6 June 2018

RE: LETTER OF DIRECTION – Waikato WTP Audit 2018

Figure 1: Waikato WTP - daily net take July 2015 - June 2017

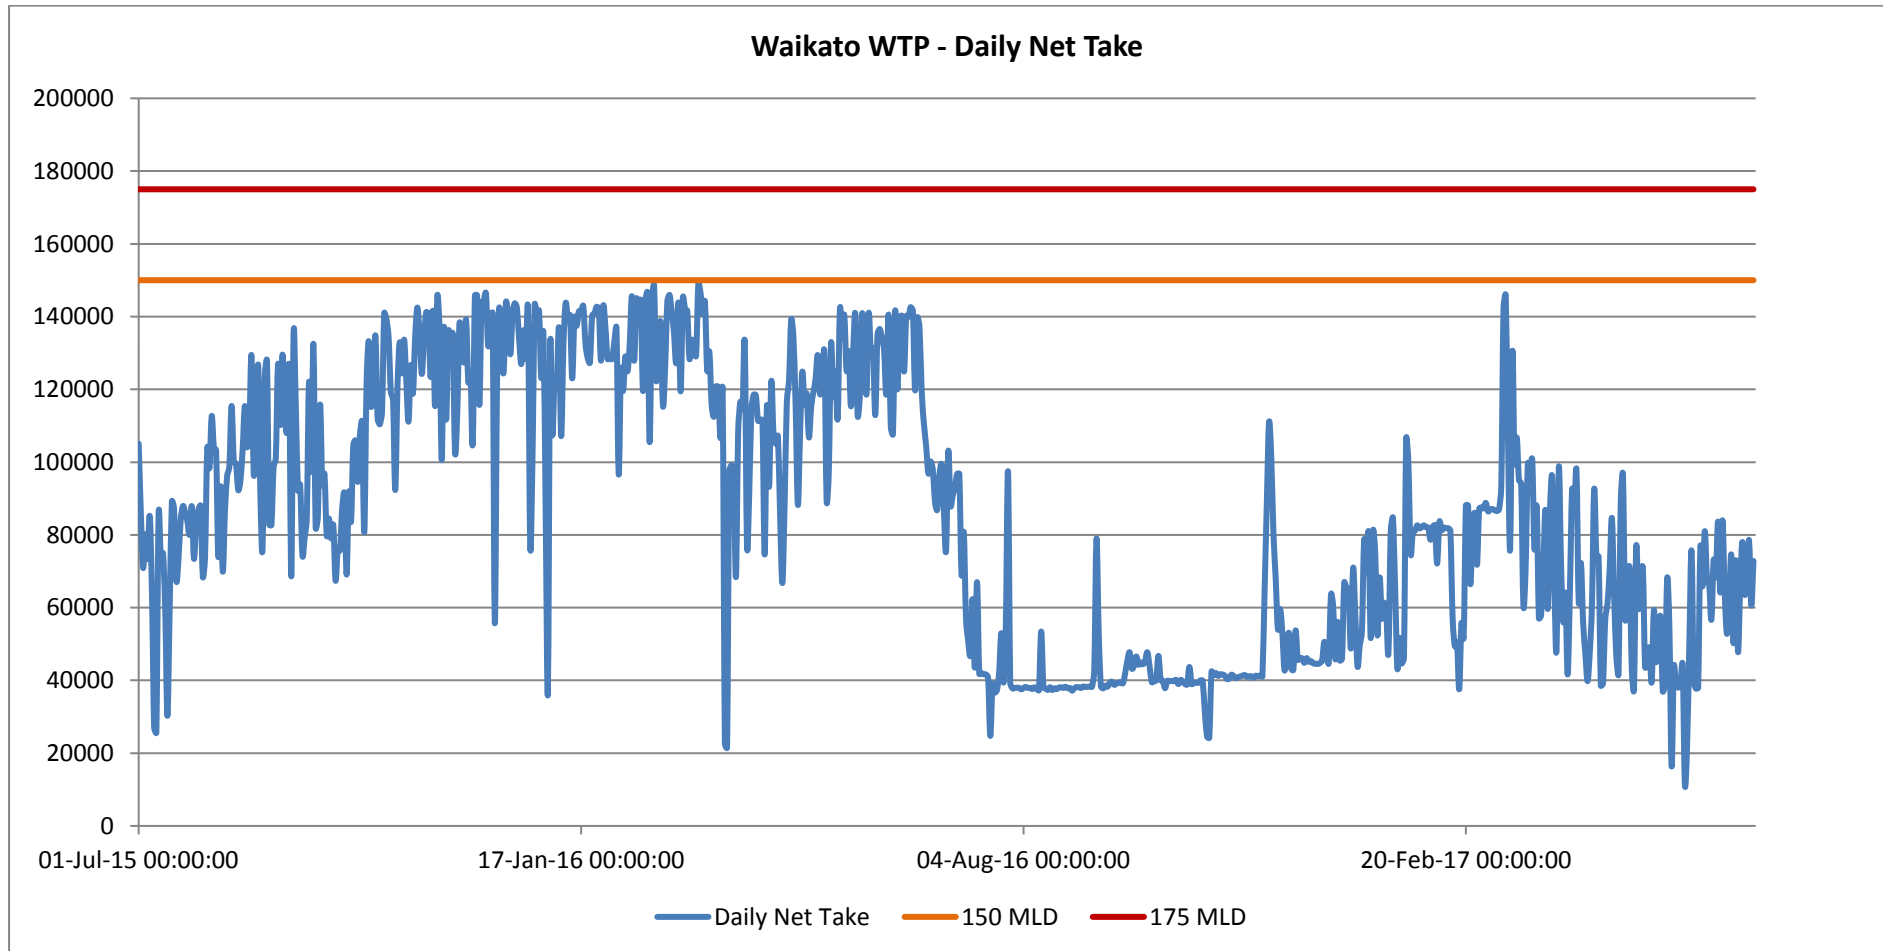
AUTH137722.01.01	4	The total combined instantaneous take rate pursuant to this resource consent and resource consent 960089 must not exceed 2,450 litres per second.	Please investigate and take action to reduce the abstraction rate to within compliant limits.	Consent 137722 was granted in February 2017 providing for a maximum instantaneous flow of 2450 l/s. The maximum flows abstracted from the Waikato River have not exceeded this level. Watercare believes that this warrants further discussion with WRC staff to confirm consent and current compliance status.
AUTH137722.01.01	5	Water must not be taken pursuant to this resource consent when the Waikato River 7-day rolling average flow at Rangiriri (Waikato Regional Council site number 1131.117, map reference NZTM 1788389 E 5855059 N), as determined by the Waikato Regional Council, is less than 328.3 cubic metres per second.	Please explain the reason for the spikes in take volume during restricted water take conditions around 7 December 2015, 21 March 2016, 15 June 2016 and 26 July 2016	Consent 137722 was granted in February 2017 after the dates of the events raised by the WRC. The graph provided by WRC displays flow rate over a 15 minute period in m3/day as opposed to daily net take. This has been discussed with WRC and a calculation added to convert flow rate to volume taken over a 15 minute period. A request

Resource consent	Condition Number	Consent condition	Action Required	Status
				<p>(No # CSR0001254) has been raised with Watercare's ECS team to create a new tag that records the net take volume over a 15 minute period. This will make the reporting of this condition clearer and avoid any confusion in the future. Figures 1 displays the daily net take for the compliance reporting period and shows that no water was taken above the 175,000 m³ limit.</p> <p>Watercare believes that this warrants further discussion with WRC staff to confirm consent and current compliance status.</p>
AUTH960089.01.03	3	<p>The maximum rate of abstraction:</p> <p>1) Rate of abstraction shall not exceed 2000 litres per second; and</p> <p>Net take volume – being the volume taken pursuant to this resource consent less the volume discharged into the Waikato River pursuant to resource consents 120246, 960101 and 960091 shall not exceed 150,000 cubic metres during any 24 hour period.</p>	Take action to ensure that discharges remain within compliant limits.	<p>Condition 3 refers to abstraction. The maximum abstraction flow rate was exceeded twice during the reporting period. These exceedences were associated with abstraction system capacity confirmation testing and should not reoccur.</p> <p>The WTP was compliant with the total daily abstraction limit during each occurrence.</p>
